Coalbed Methane Stream Depletion Assessment Study – Raton Basin, Colorado

S.S. PAPADOPULOS & ASSOCIATES, INC.
Boulder, Colorado

March 2008

Reviewer's Comments and Response to Comments

Figure 5.1 Long-Term Average Regional Water Table in the Raton Basin (after Watts, 2006)

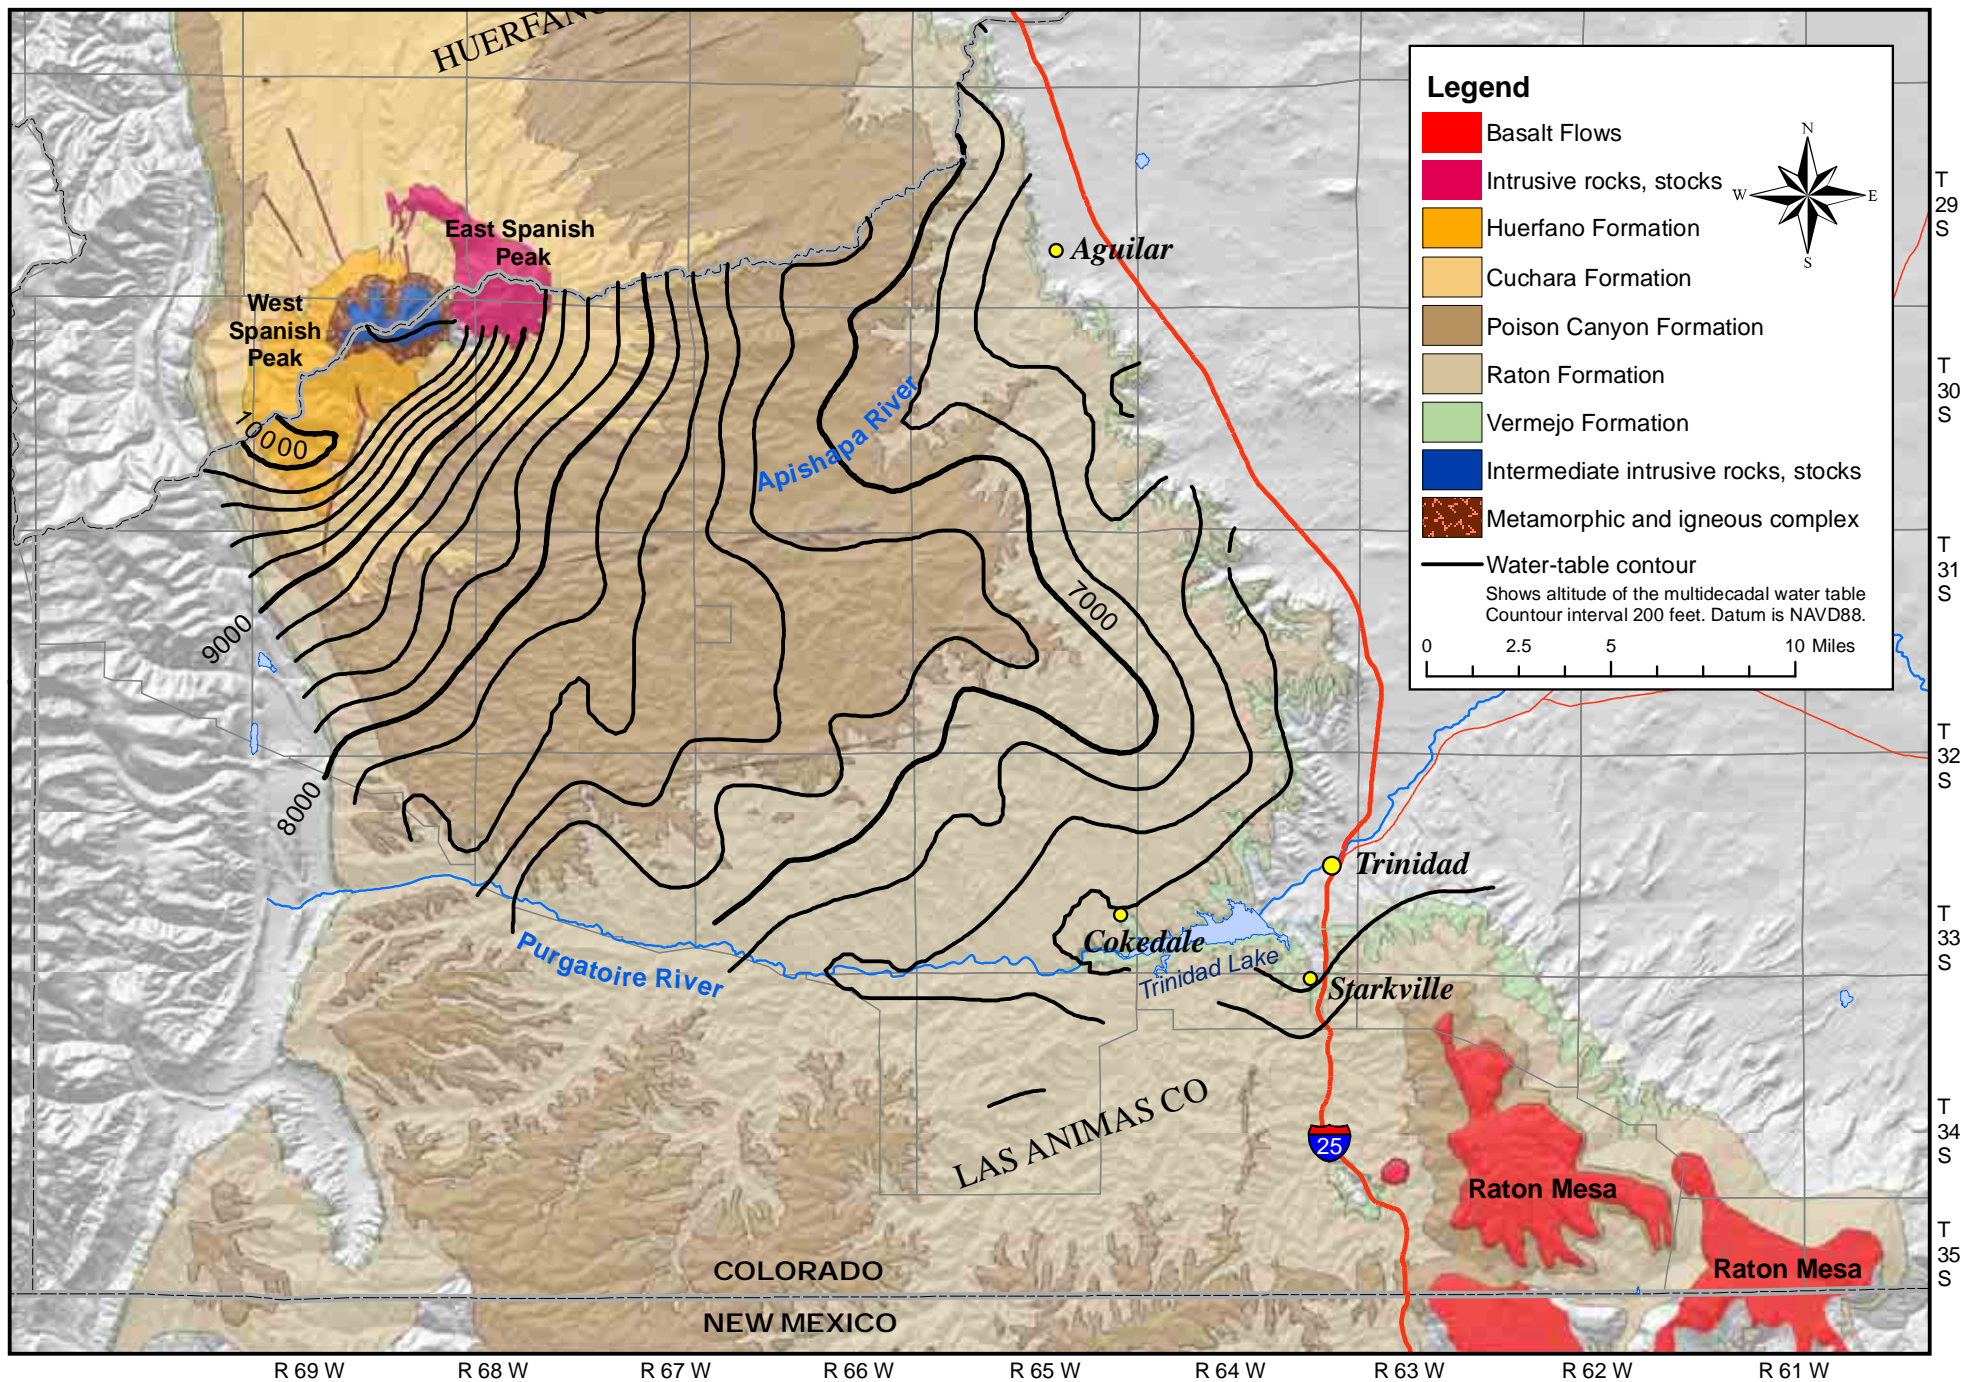
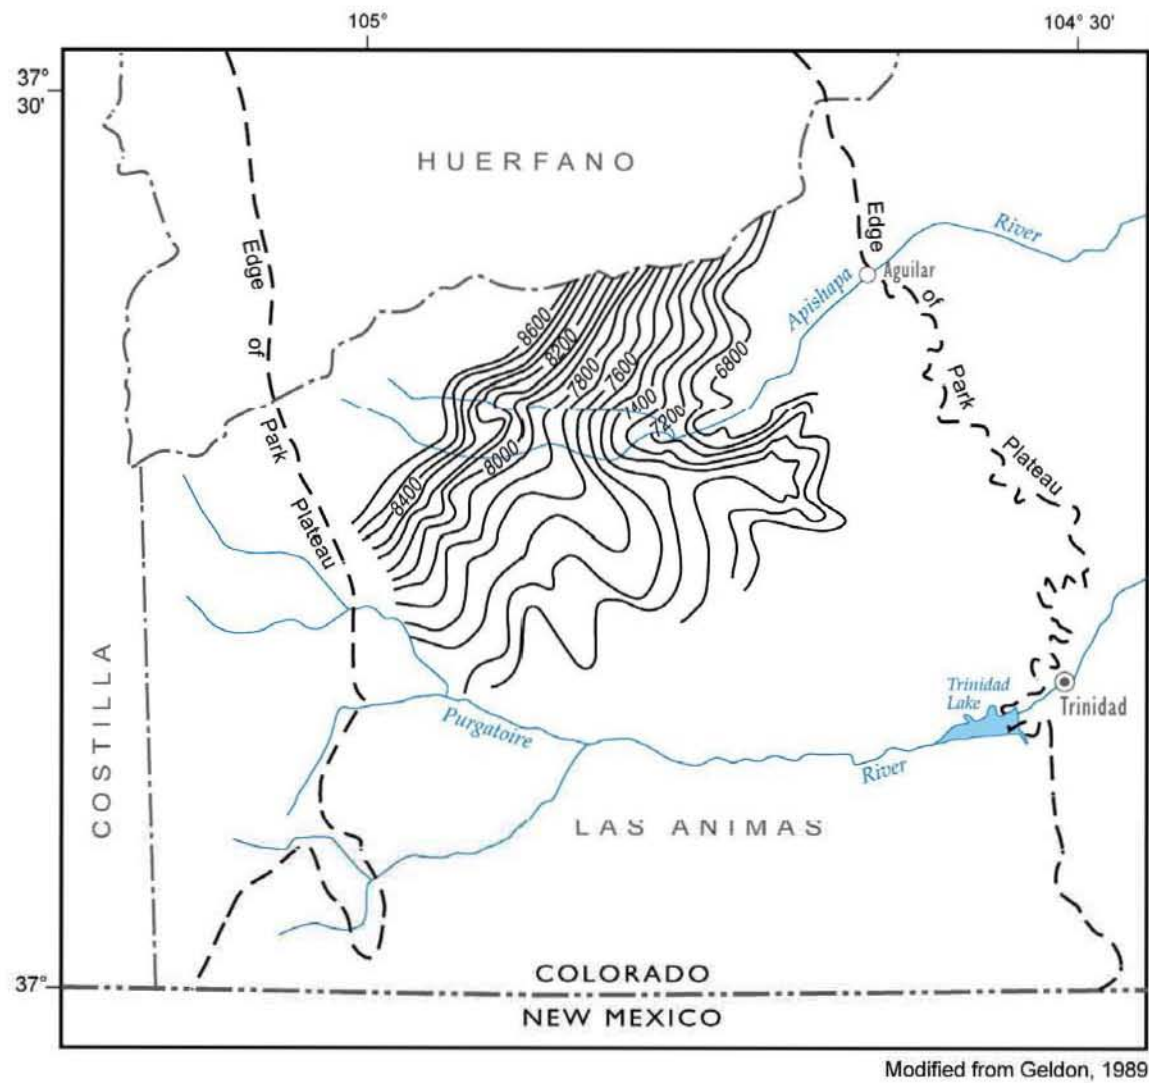
5. Comment: *The up-stream deflection of potentiometric contours across the Apishapa River Valley (Figures 5.1 and 5.3) clearly indicate that the Apishapa River Valley is a ground-water discharge area. Whether or not the stream is perennial or intermittent is irrelevant for stream-depletion analysis. When ground-water pumping reduces potentiometric levels in an aquifer adjacent to a stream, it will capture streamflow; increase the capture of rejected recharge (run-off); or intercept ground water that would have discharged to a stream. (See USGS page 2)*

- 6) **Page 32, last paragraph, 2nd sentence, and figures 5.1 and 5.3:** If flow is generally from west to east (high elevation to low elevation), the area to the east should be a discharge area. [Also see Geldon, 1989, figure 54; and Abbott and others, 1983, figure 8.1-1]

- 32) Figures 4.4 and 4.5:** Add date range or end date of accumulation. Add note about volume equivalents of BBLs.
- 33) Figure 5.1:** (after Watts, 2006[a](#))

Figure 6.4 Estimated Stream Depletion, Cucharas River

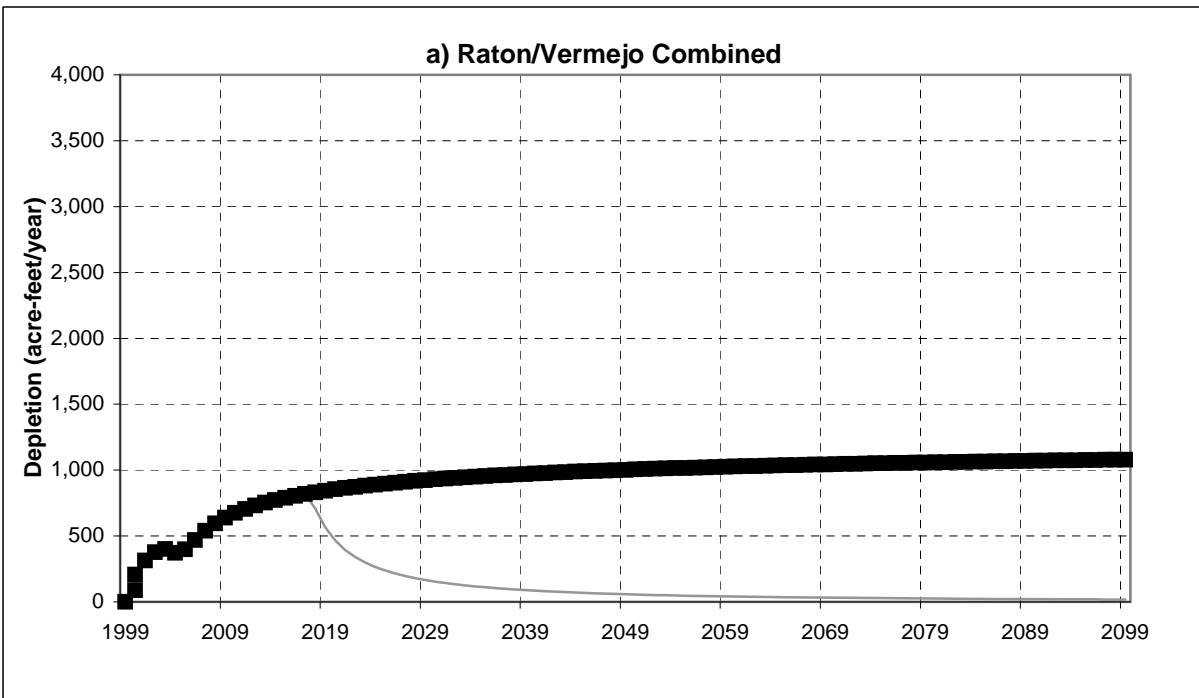
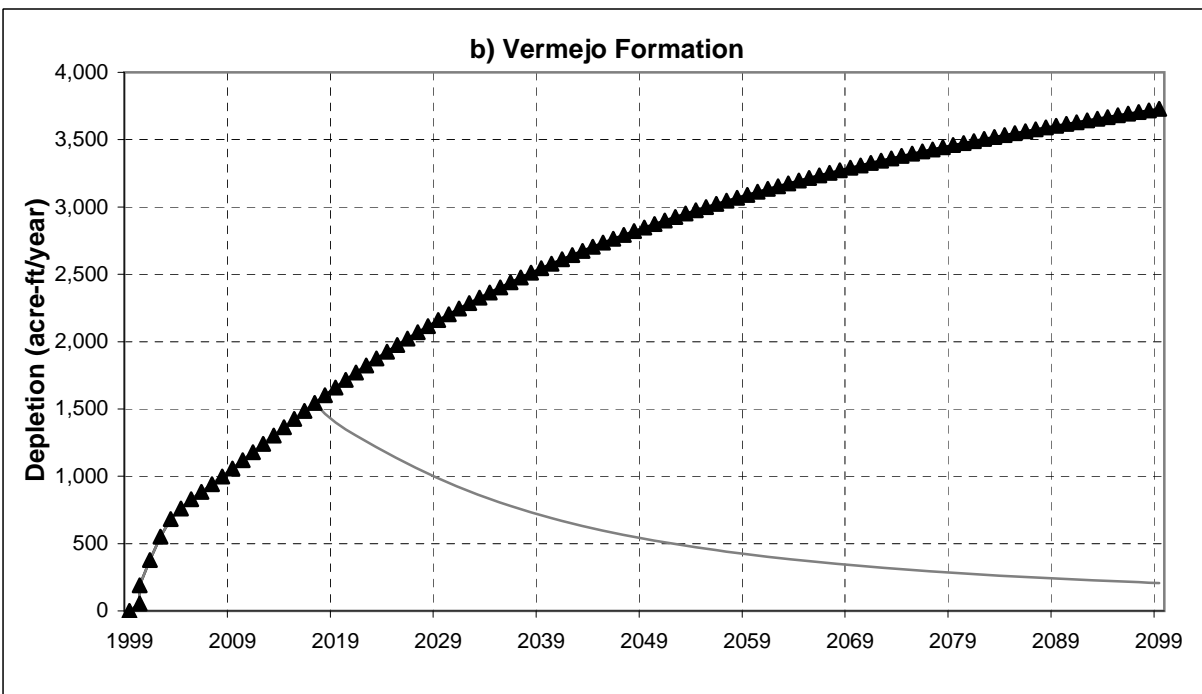
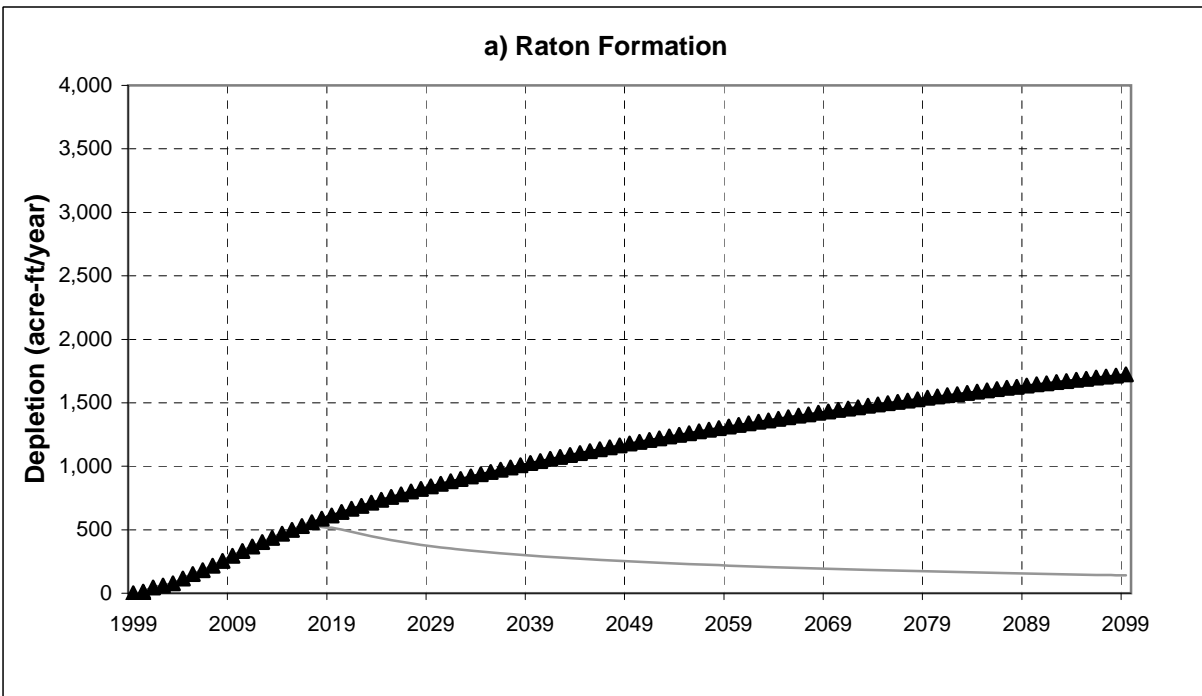
- 34) Figures 6.4 and 6.5:** Could you add the ratio (q/Q) on the right-side y axis?
- 35) Table 5.1:** Robson (1983) and Geldon (1985) not included in References.
